Mottagare: Kontrollanter, kontrollantelever, klubbar, MC Norden, HL		Datum: 2016-10-04	Bilaga 1 st	Blad nr: 1 av 1
		Ärende: Materielvarning nr. 3/16		
Fastställt av MK: 2016-10-04	Ersätter:	Utfärdare: SFF Materielkommitté (MK)

“m2 AAD Cutter Replacement, BN: 02/09/2016 ” daterad 2016-09-30

1. Issue Date : **September 30, 2016**
2. Bulletin number : **02/09/2016**
3. Subject : **m2 AAD Cutter Replacement**
4. Status : **Mandatory**
5. Identification : **Identification of affected m2 AAD cutters**

Fig.1

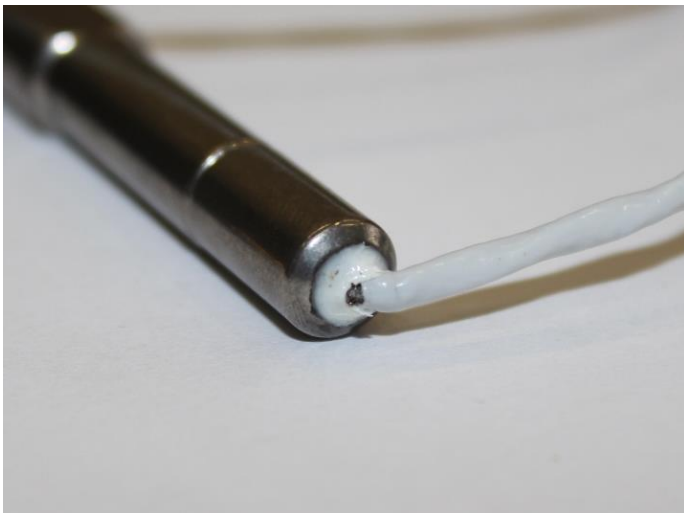
The cutter cable insulation has cracked on some MarS m2 AAD cutters as shown in Fig. 1. Investigation by the manufacturer has shown that this is caused by the method used to close and seal the cutter body. The cracking only affects the insulation, and the function of the device is unaffected. However, as a precaution, all cutters that are affected by this bulletin must be replaced.

a. If a problem exists with the cutter this will be detected by the control unit and displayed as an error No.2. In this case, the cutter must be replaced immediately.

b. If no error is detected, then the AAD may remain in use until the next repack cycle. During the next regular repack the cutter must be inspected and replaced if it is affected by this bulletin.
